**City of Poughkeepsie
Planning Board
Meeting Agenda**

Common Council Chambers
Tuesday, July 19, 2022
6:00 PM

**CITY OF POUGHKEEPSIE
PLANNING BOARD
DRAFT MINUTES FOR
JUNE 22, 2022**

Project: 15 North Cherry Street
Subject: 15 North Cherry Street Application for Site Plan & Façade Review

3 SITE PLAN.
1/16" = 1'-0"

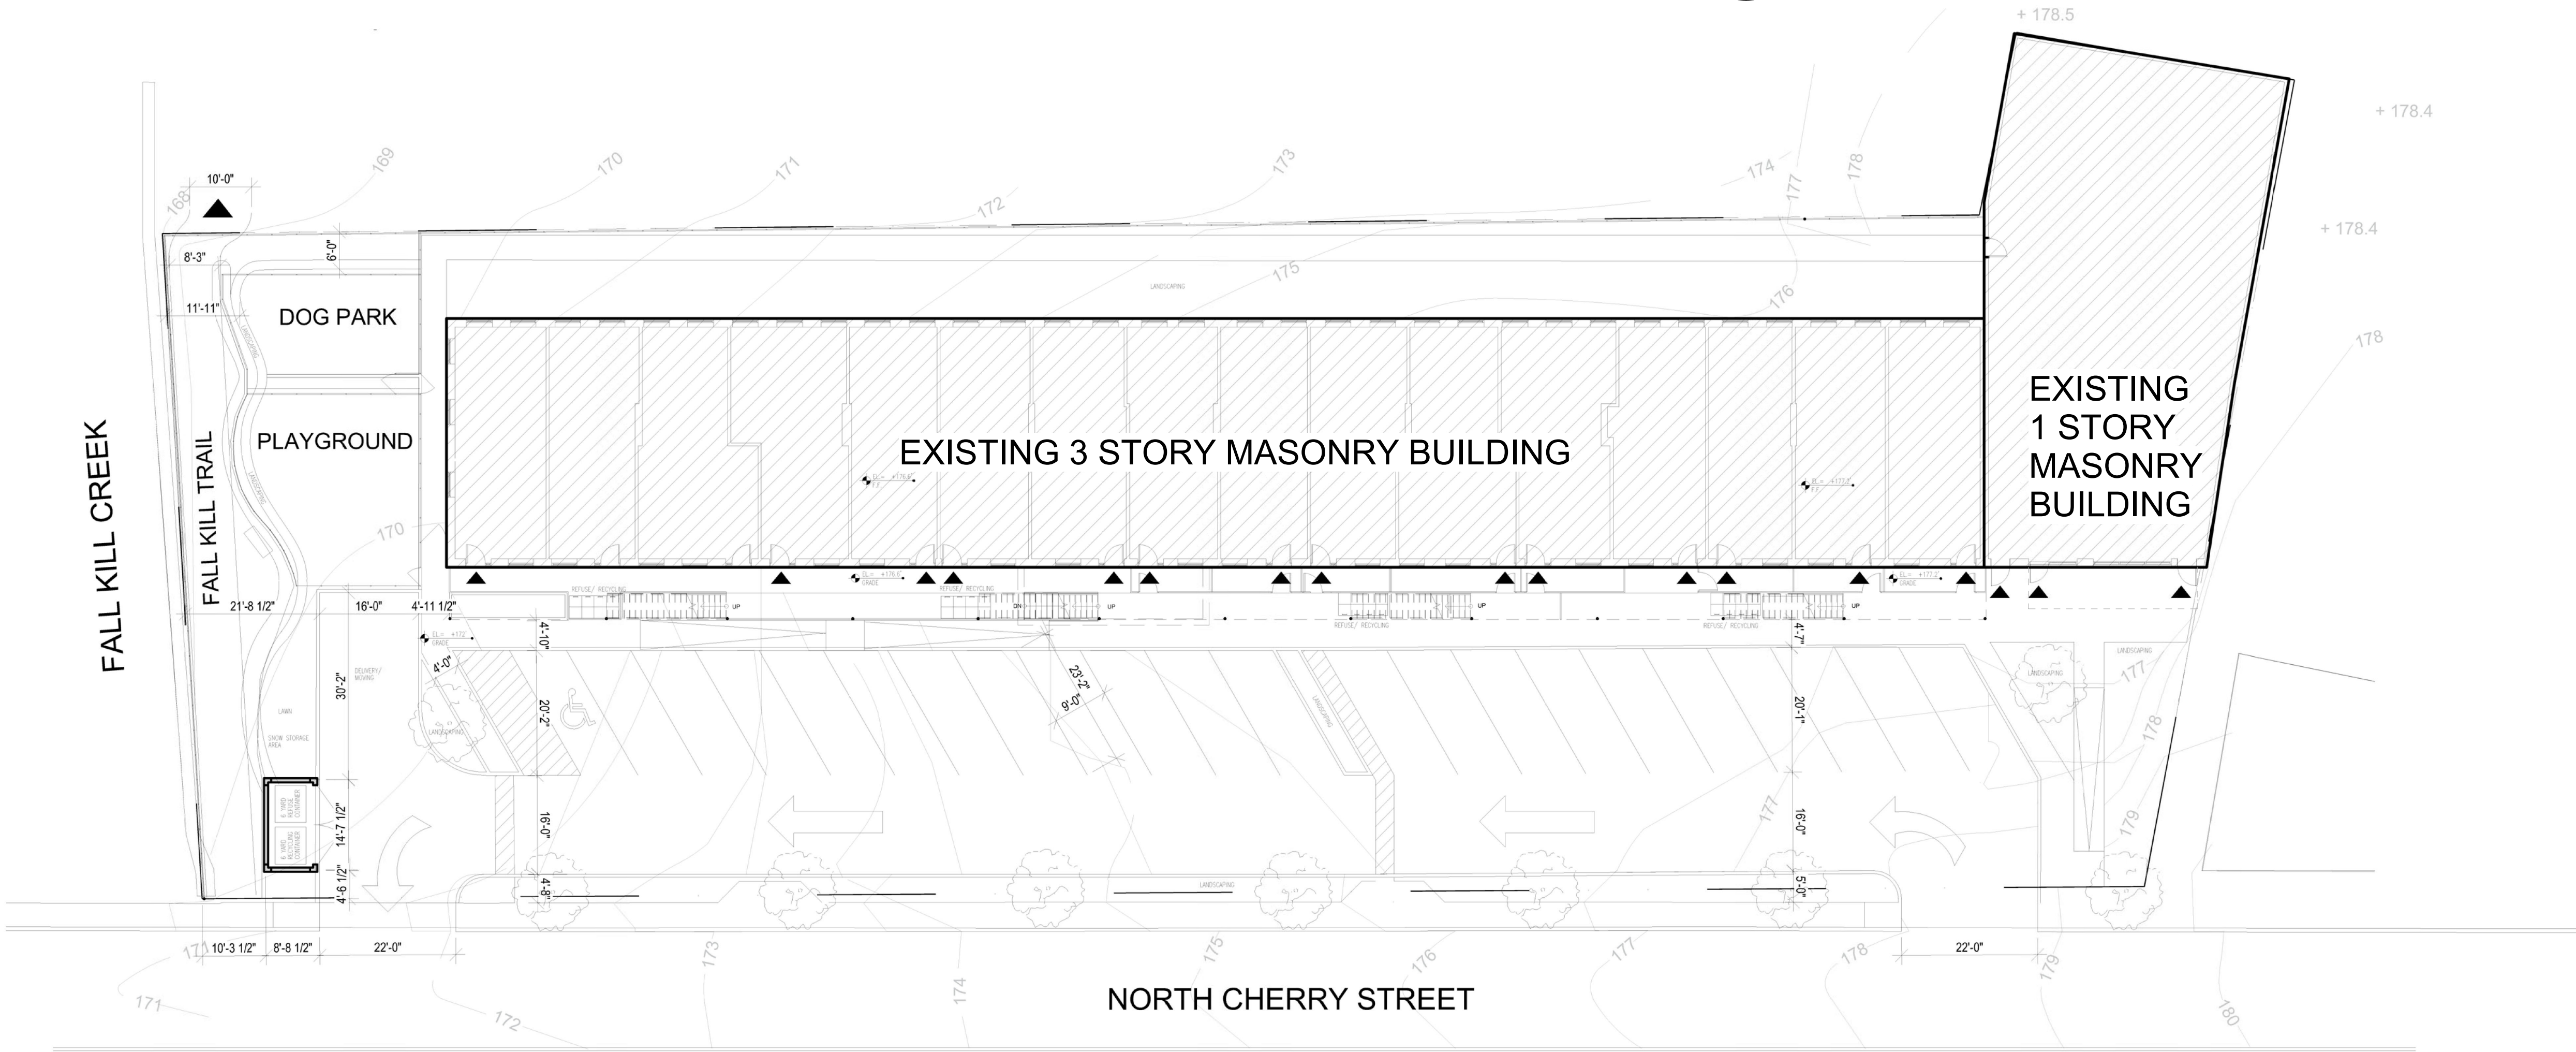
8. Yes ☒ No ☐ The applicant should be notified that the Dept. of Public Works/Engineering requires the following comment(s) be addressed:
 1. The sewer is shown connected directly to a manhole. A connection to the 10" sewer main is preferred. If a connection is made to a manhole, and outside drop connection is required.

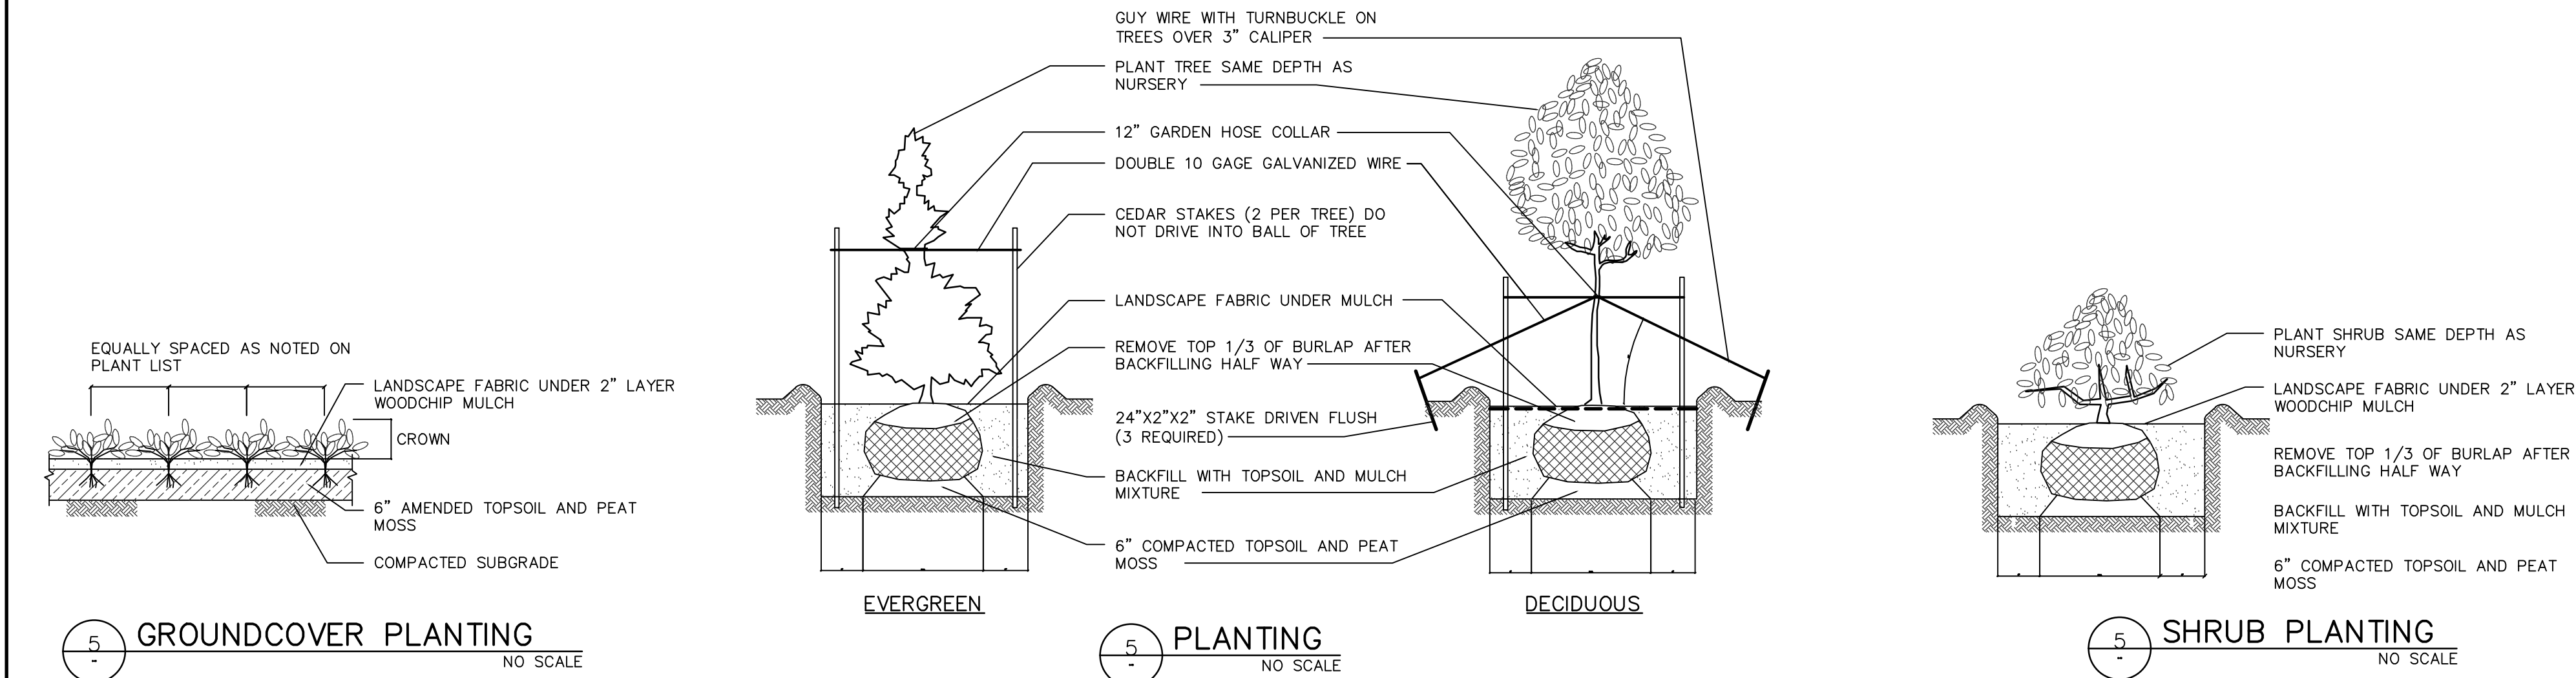
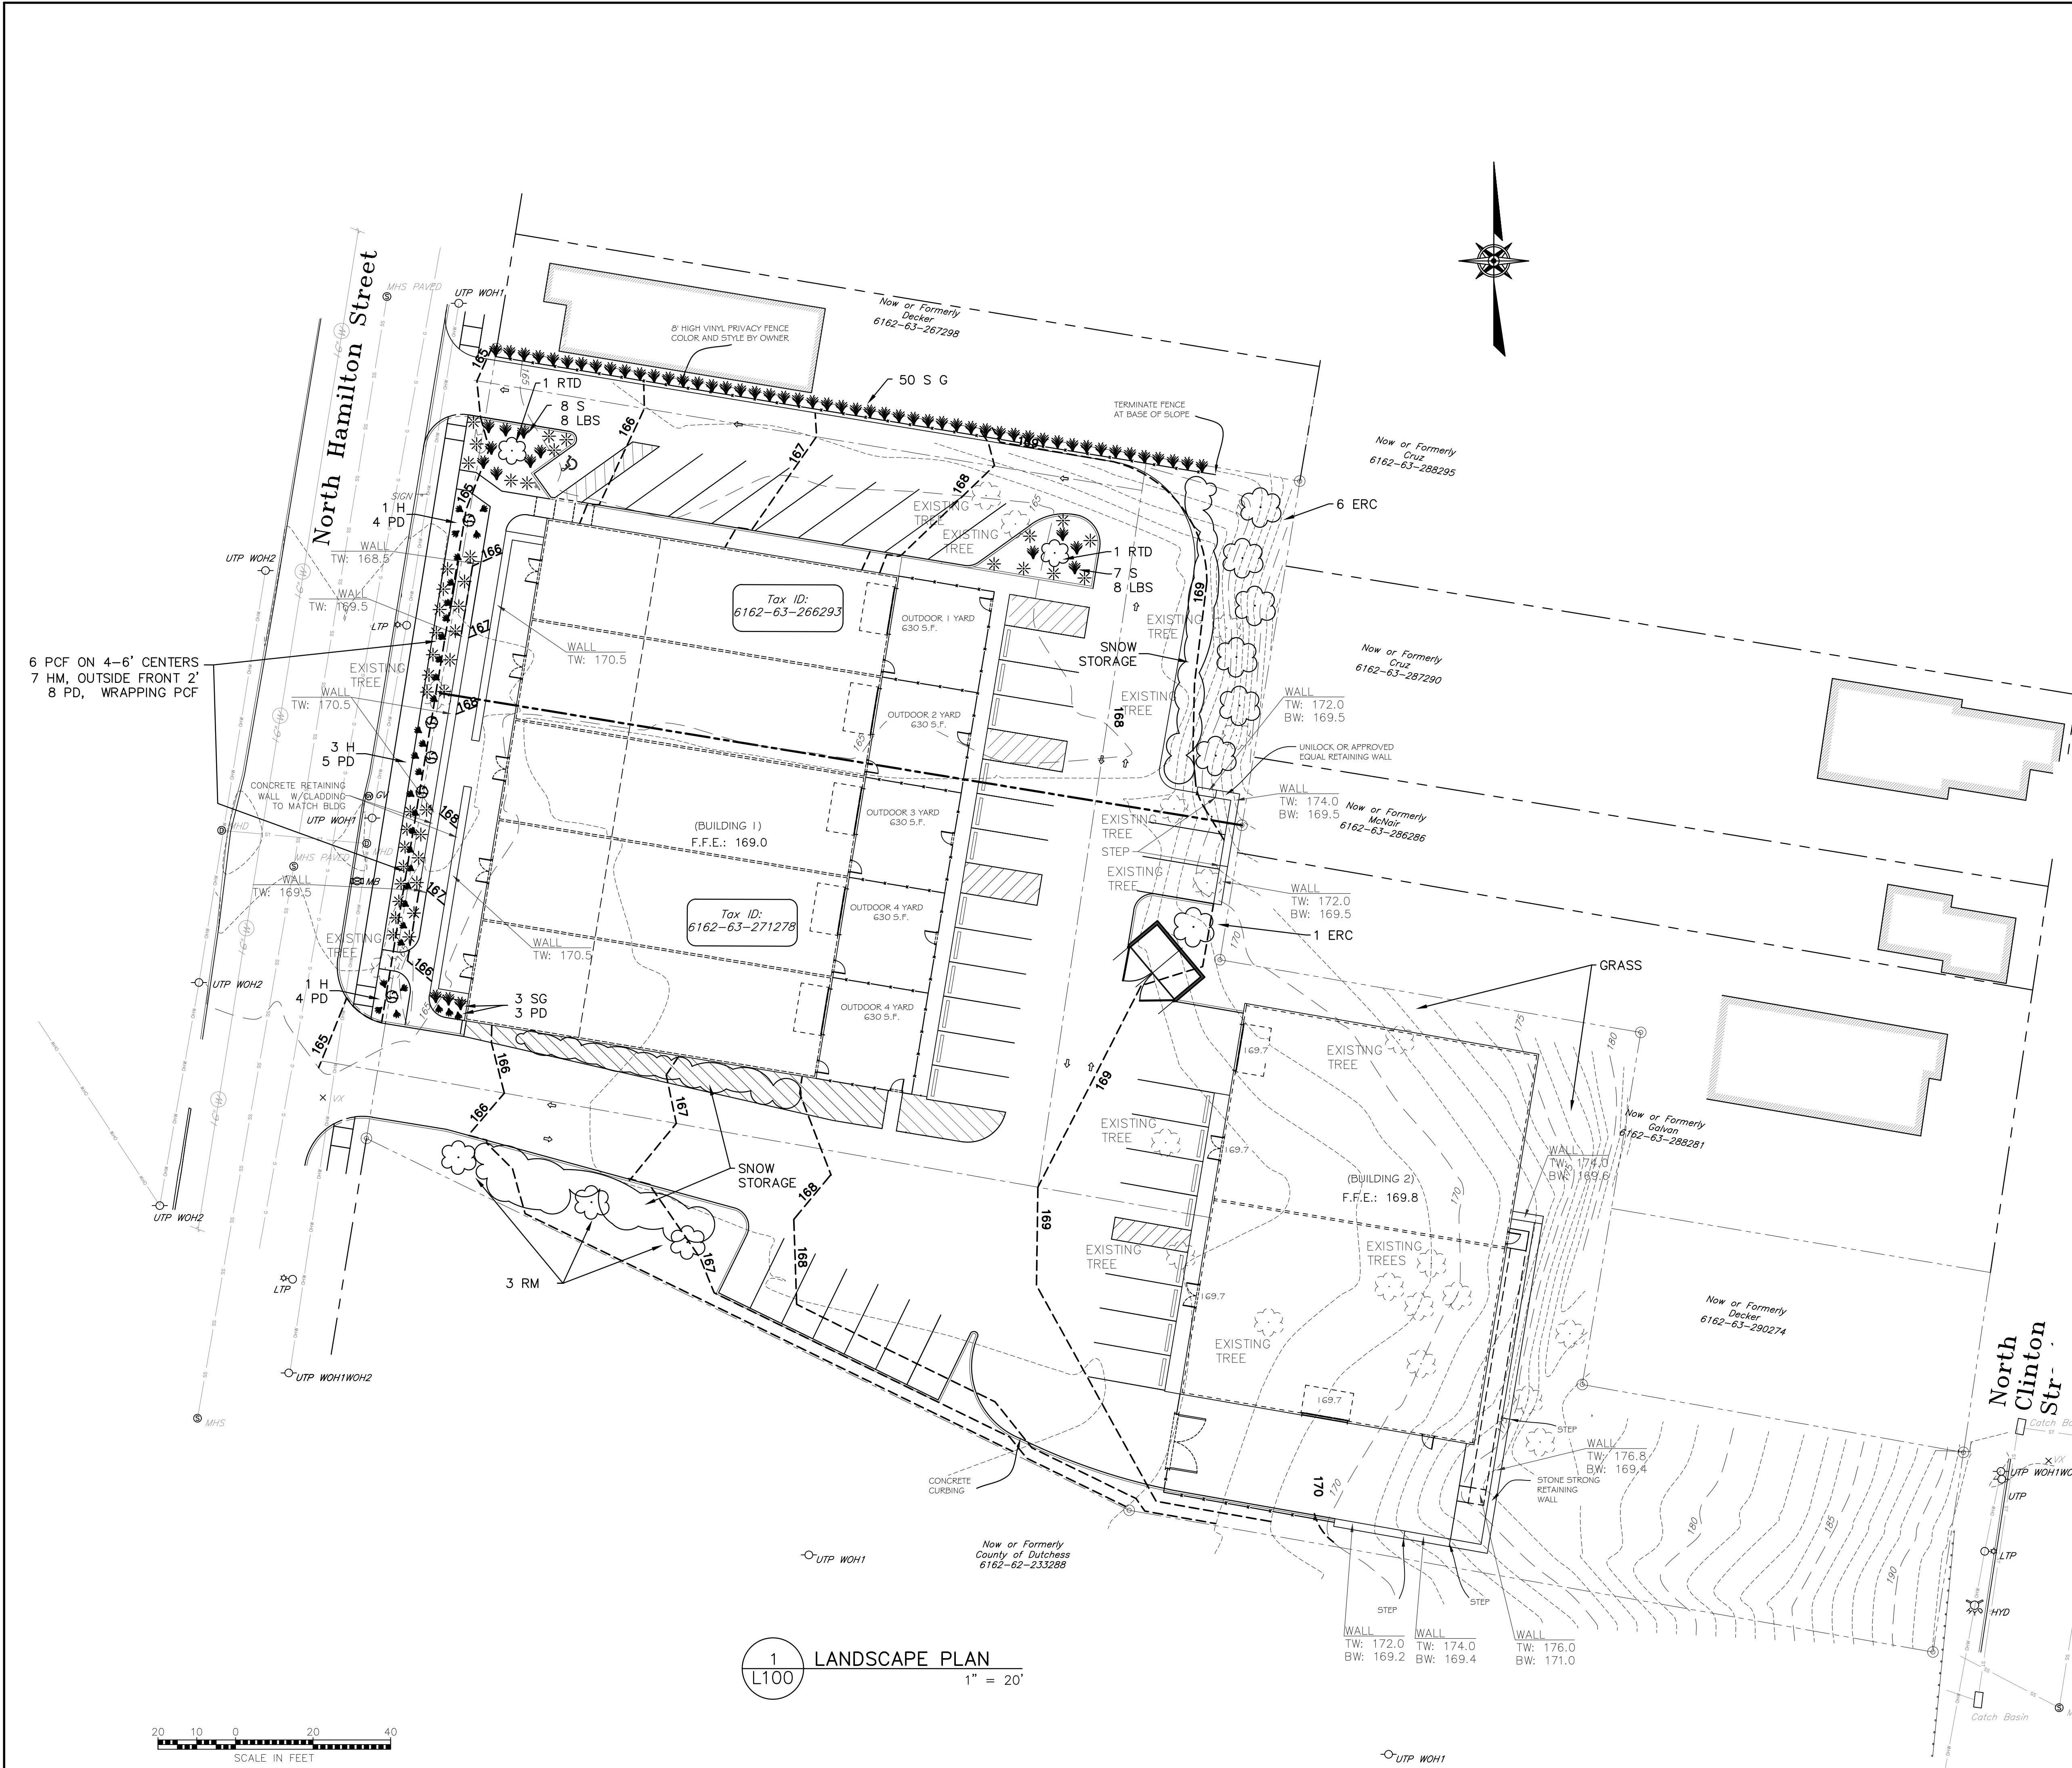
ADDITIONAL COMMENTS

1) NO SNOW STORAGE SHOWN

2) NO REFUSE AREA SHOWN

3) VISUAL DETAILS ON RETAINING WALLS
